Written submission in response to email received 20 July 3:44pm 2022 in relation to the Development Determination Panel scheduled to commence 10am 27 July 2022. Prepared by Nick Holcombe, Bachelor of Civil Engineering, owner of 67 Hillside Road. Application is in relation to DA No. DA2021/2622 for Address: 65 Hillside Road Newport

Summary of submission contained in this document

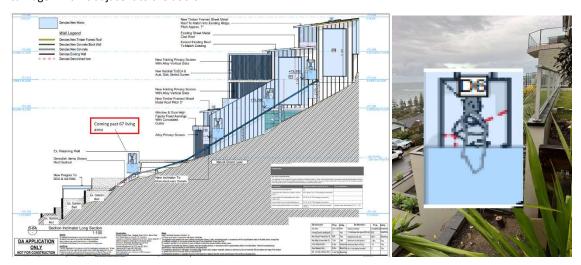
With respect, this statement is slightly misleading. The new track location only deviates away from the living area to the eastern end and below the ground floor living area, and the deviation does practically nothing to improve the situation in the living area at 67. The ground floor living area I refer to is shown in the picture below, a side view of 67 Hillside taken from the north. I will use the double glass doors in the picture below to demonstrate the effect of the inclinator carriage at that point. This detrimental effect will also continue several metres to the west from the double glass doors adjacent to and along the deck.

Using the DA drawings provided, an elevation looking from 67 to the north, I have copied and pasted the image of the inclinator carriage to place it such that it would be adjacent and directly in view to the double glass doors in our living area. See the annotation bordered in red on the diagram below left which points to where I have pasted the image of the carriage which is adjacent to the doors.

To determine the approximate effect of the carriage on the view from the edge of our house in that area I have overlaid the image of the carriage on a photo taken from the edge of our house (image above to the right). This is my best attempt and may be plus or minus a margin of error but is the best I can do with the available material. The carriage will continue to be similarly obstructive as it travels several metres to the west adjacent to our deck from the double glass doors past the kitchen window and then past a bedroom window. The carriage then ascends as it goes to the west and would be visible from our bedrooms to the west on the next level.

This would clearly be extremely confronting for the occupants of our house. Additionally, part of the reason given for not adhering to Control C1.19 is "the footprint of the existing dwelling". We note that the dwelling footprint is well to the west of the living area and that there would be scope to move the inclinator to the south and below the view of our living area. We request that for these reasons and the transgression of control C1.19 the inclinator be disallowed. There is a possible additional consideration that there is in my assessment a one hundred year old retaining wall on the boundary, just on the 65 side, which in my opinion would need to be removed if the inclinator structure needs to be constructed near it. This would be damaging heritage works, and in my opinion, would also be a very difficult engineering task to complete without affecting 67 given it is so close to the boundary.

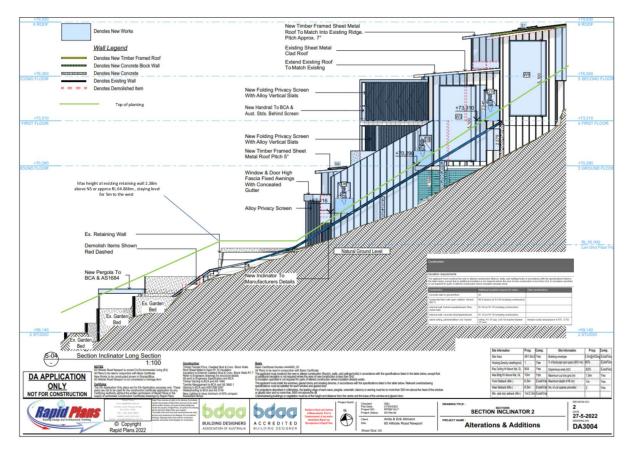
- That it extend on the edge of 65 Hillside Road northern boundary from within metres of the eastern boundary (as it did in the past) to the western boundary in a manner consistent with my drawing below. The green line is the requested maximum elevation of the fully grown planting.

- That the section of the planting that goes from the existing retaining wall (marked on the diagram below) be maintained to limit the height at no more than approximately 2.38m above the current natural surface level at the base of the existing retaining wall eg no more than an estimated 64.866m RL (using the RLs from the DA diagram and to be confirmed upon approval that RL matches 2.38m above the natural surface at that point) extending horizontally 5 m to the west. It is expected that the top of the planting from the point of the existing retaining wall going to the east will fall away roughly parallel to the existing ground level but in the event of excess growth they also need to be maintained to be no more than a height of 64.866m RL. The height of the remainder to conform with the guidelines from the landscape referral response.

- This will mean that the section from the Eastern extent to existing retaining wall will actually approximately reinstate the previous planting which was removed by the current owners of 65

- That no permanent structures such as fences be built along the boundary. If this isn't possible, that any structure
 be on the south of the planting and to be slightly below the height levels of the planting such that it is hidden
 from 67 by the planting, and not be to our cost.
